APPLICATION FOR PERMISSION UNDER SECTION 16 OF THE TOWN PLANNING ORDINANCE (CAP. 131)

For Official Use Only 請勿填寫此欄	Application No. 申請編號	A/YL-LFS/570
	Date Received 收到日期	21 AUG 2025

Applied use/ development 申請用途/發展	擬議臨時露天存放五金零件（為期3年） Proposed Temporary Open Storage of Hardware Accessories for a Period of 3 Years

TEMPORARY DRAINAGE PROPOSAL

LOCATION PLAN OF EXISTING DRAINAGE SYSTEM

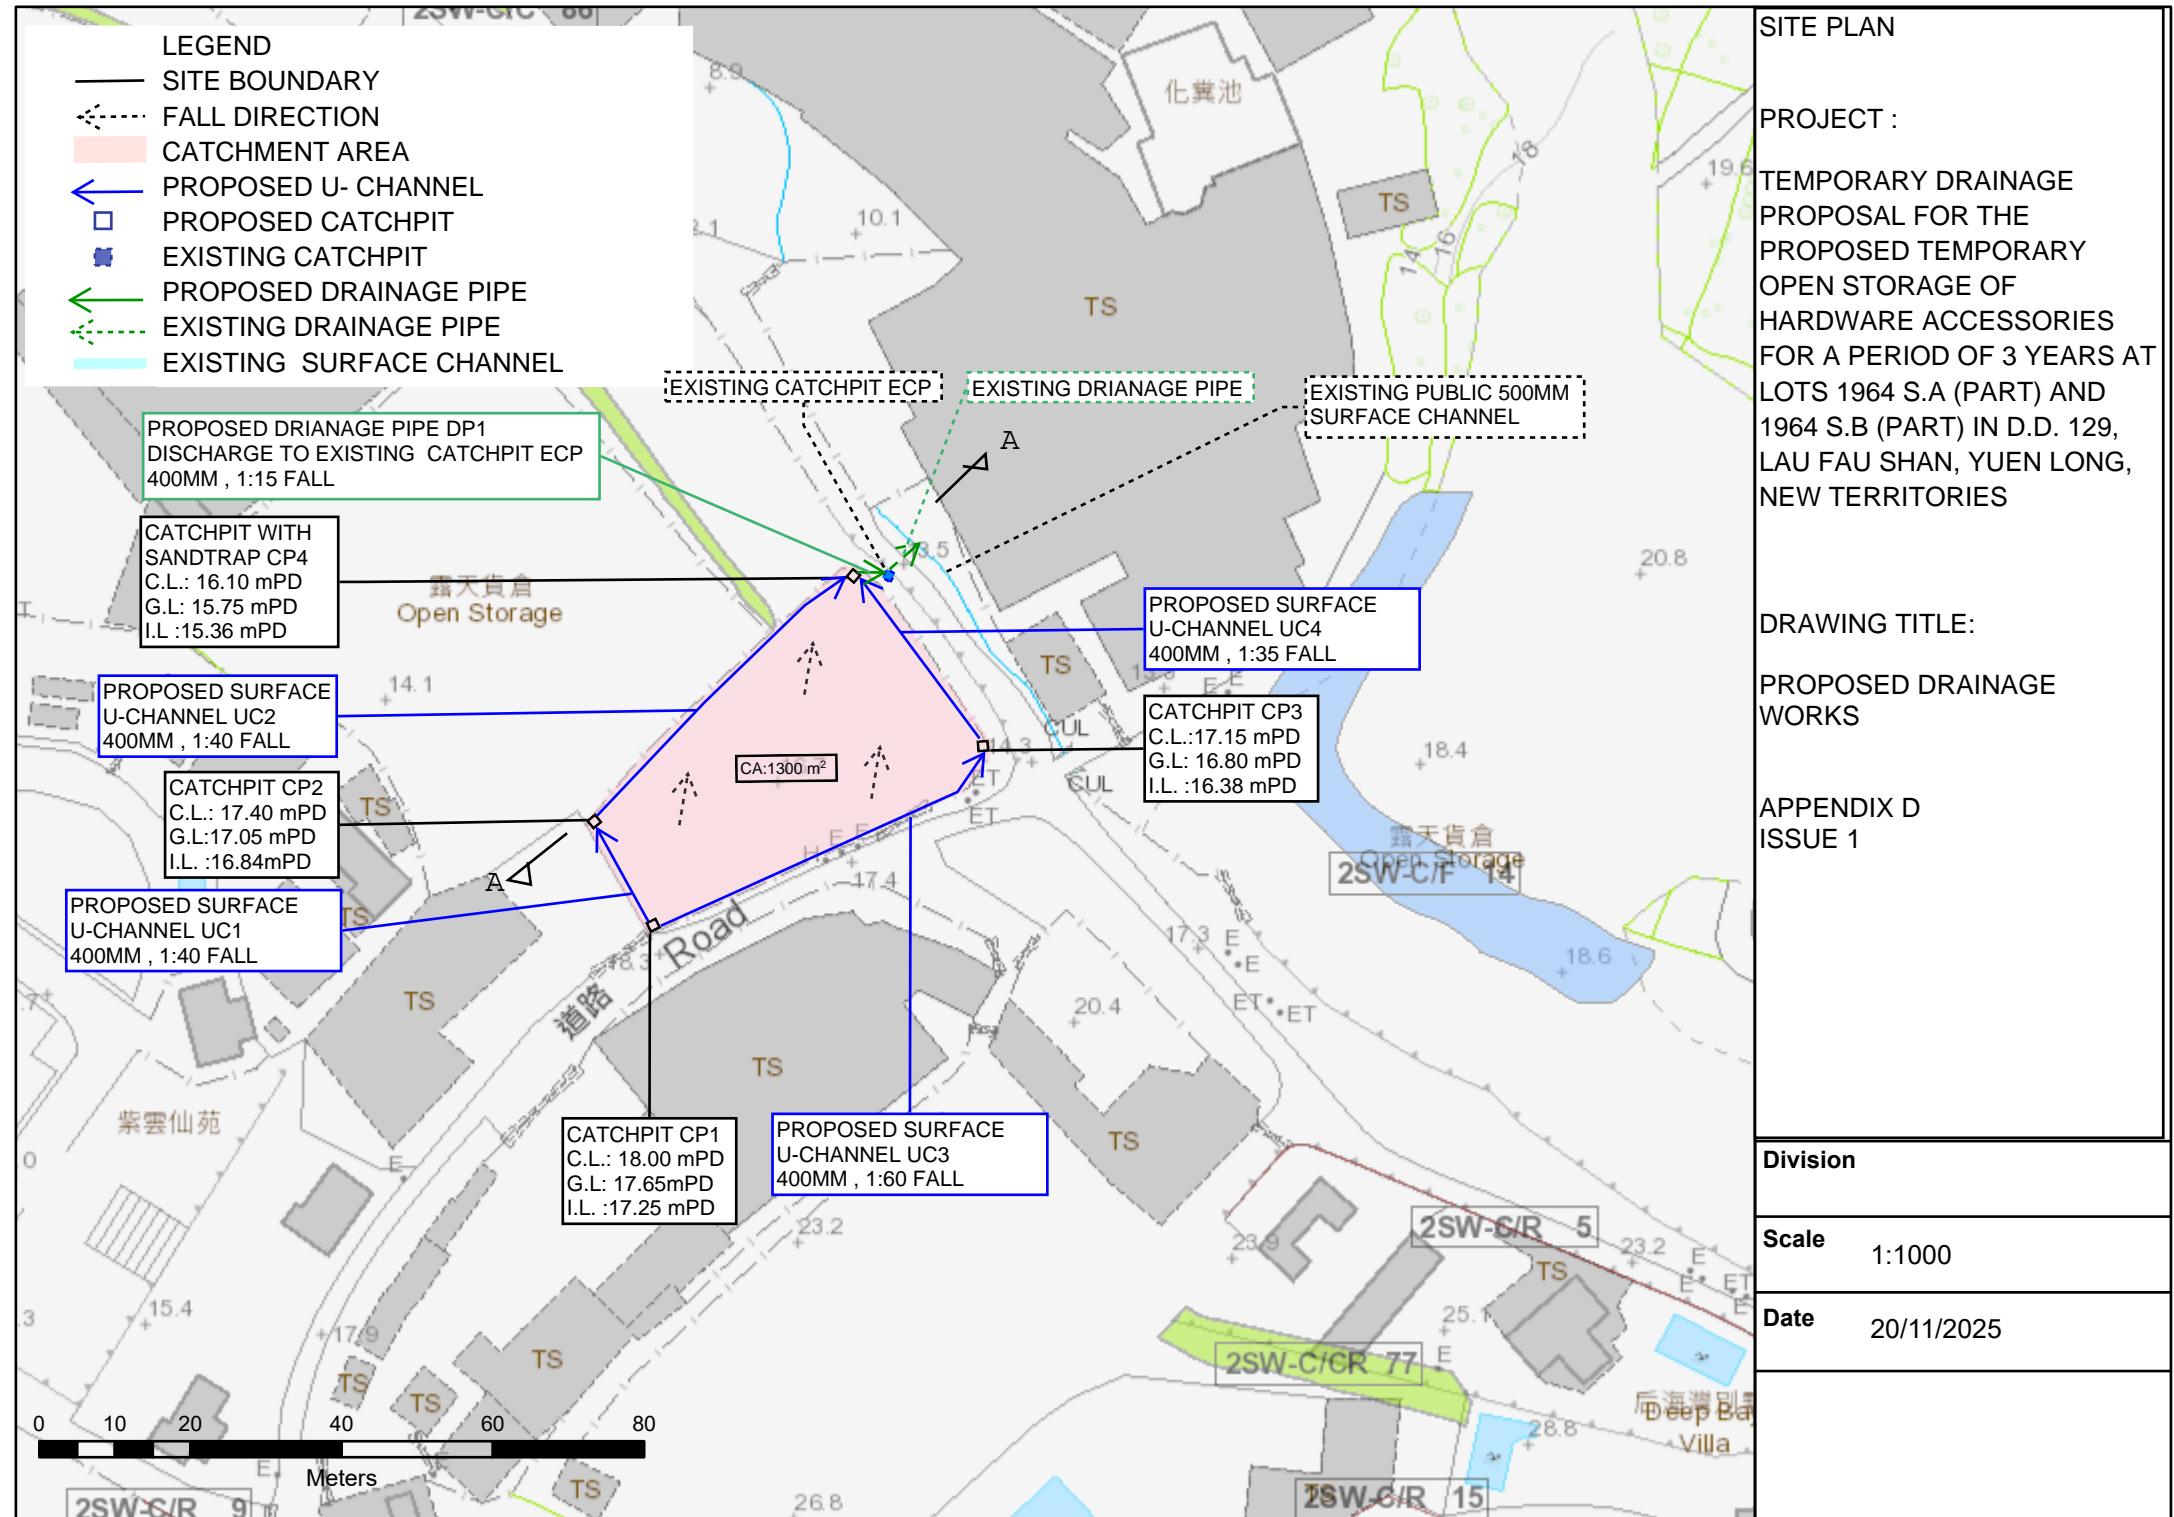
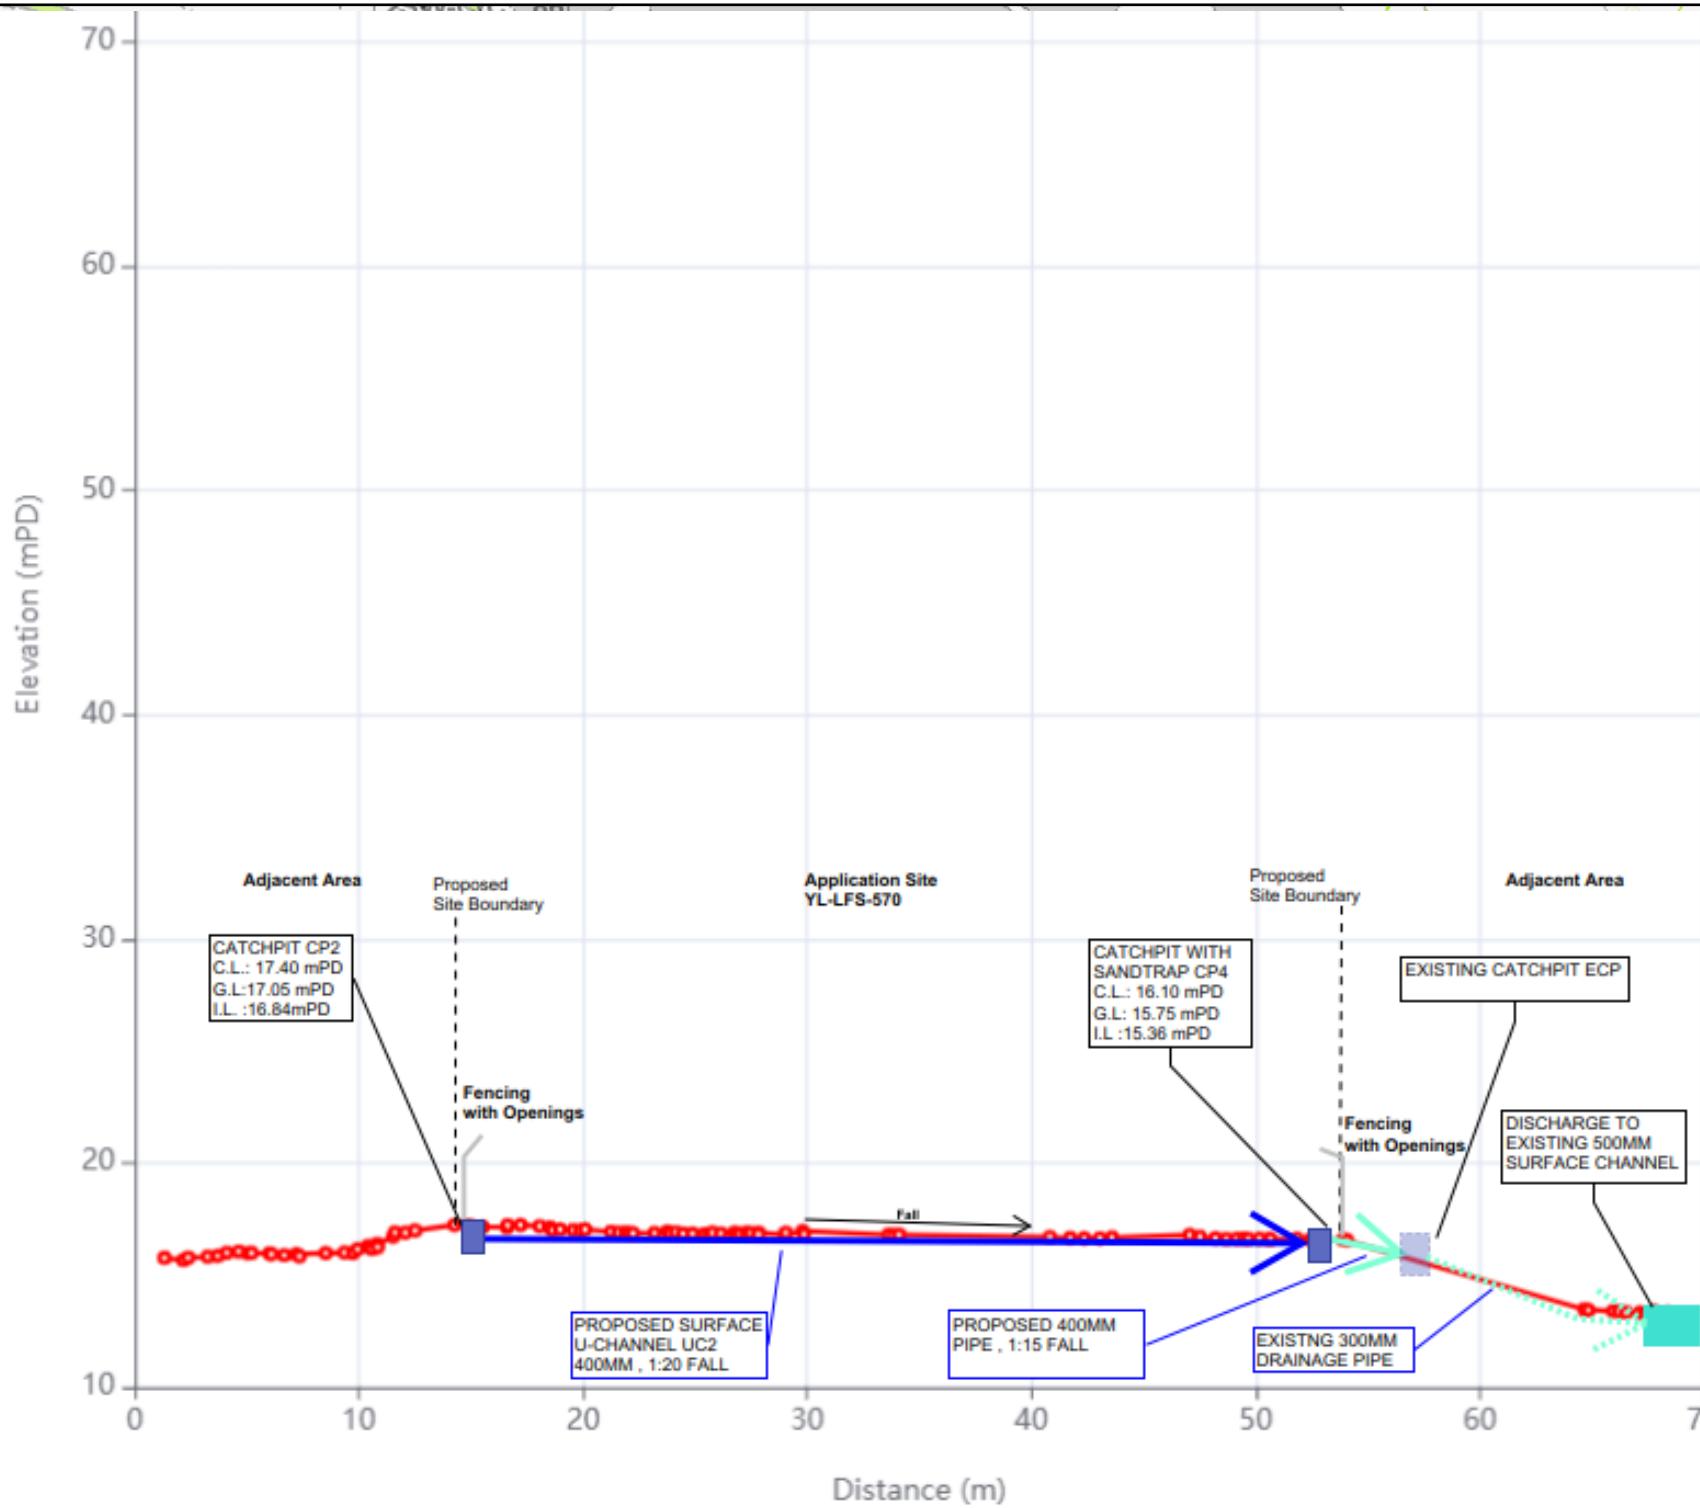
- (v) in the submitted photos, please justify the existence, dimension and condition of the underground existing 300mm dia. drain;
- (vi) in the submitted photos, please justify the dimension of existing 500mm surface channel. Please provide more photo to show its internal condition, and ensure the channel was properly and regularly maintained;

- (vii) please provide more photos along the full alignment of the discharge path from the application site all the way down to the ultimate discharge point;
